MONTGOMERY COUNTY PLANNING DEPARTMENT
THE MARYLAND-NATIONAL CAPITAL PARK AND PLANNING COMMISSION

MCPB
Item No.: 14
Date: 7/19/2018

Avalon Residential: Preliminary Plan No. 120180110

Staff Report Date: July 6, 2018

Figure 4. Preliminary Plan detail.

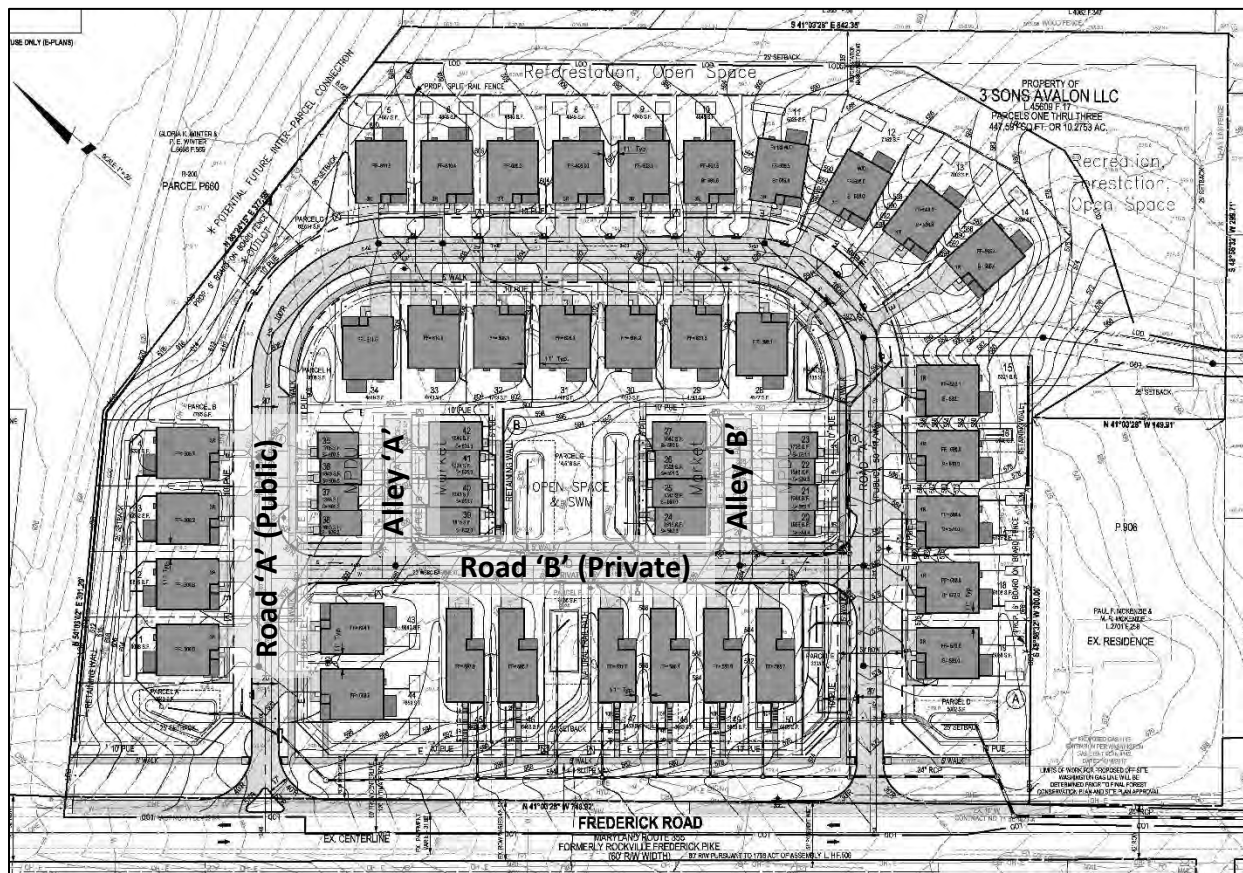
The Preliminary Plan places only single-family detached units around the perimeter of the Property; the townhouses and some additional detached units are placed in the interior.

Figure 5. Approved Floating Zone Plan H-115.

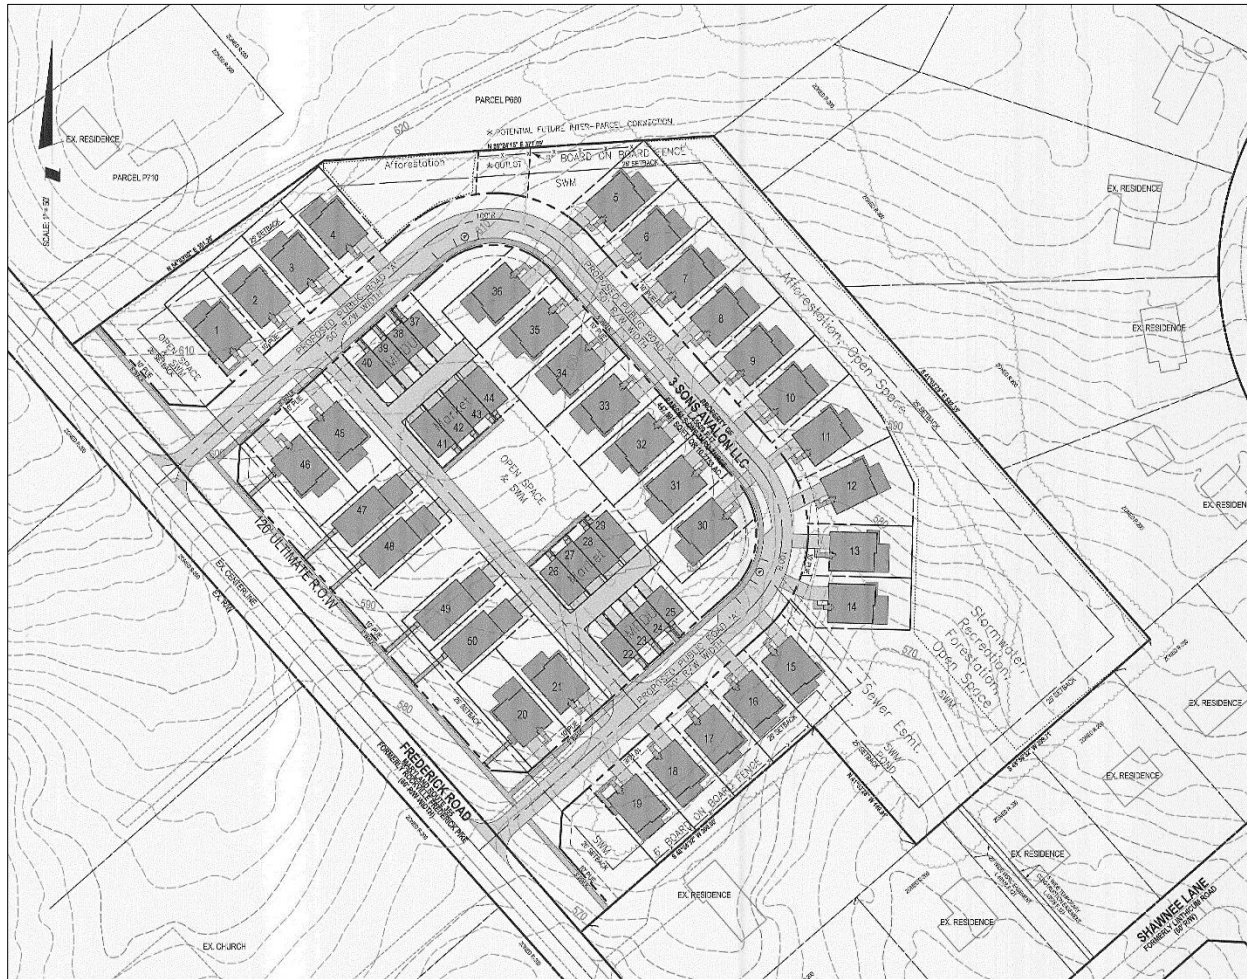
The Application remains substantially unchanged from what was approved by the District Council. As conditioned, the Preliminary Plan will comply with the conditions of the LMA approval.

Figure 6. The location of the site within the Transit Corridor District in the Master Plan.

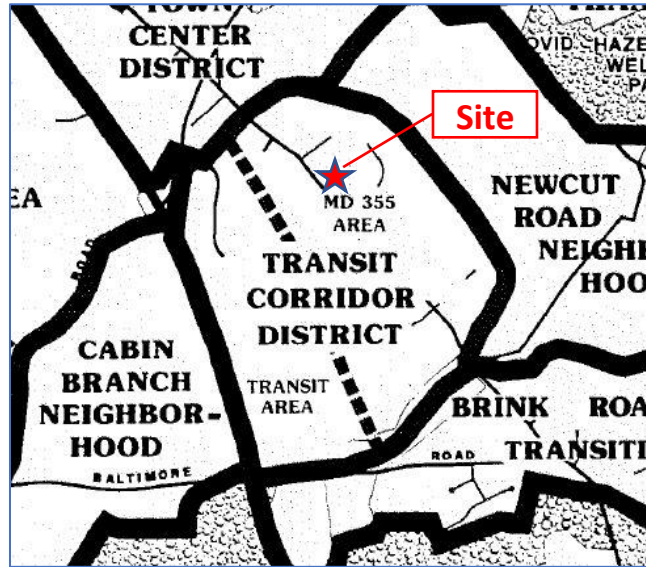
The Master Plan places the Property in the Transit Corridor District (Figure 6). The first of the relevant plan objectives for the Transit Corridor District is to “continue the present residential character along MD 355.”

The Applicant’s proposal meets the objective of continuing the residential character along MD 355 that was present in 1994 when the Master Plan was approved. As stated in the Master Plan, the Transit Corridor District “includes properties fronting MD 355 which have developed over many decades in accord with traditional patterns found elsewhere in the ‘Up-County’: single-family detached lots fronting the road. The most significant planning challenge here is to maintain and continue this residential character while addressing the need for increased traffic capacity along MD 355” (p. 54).
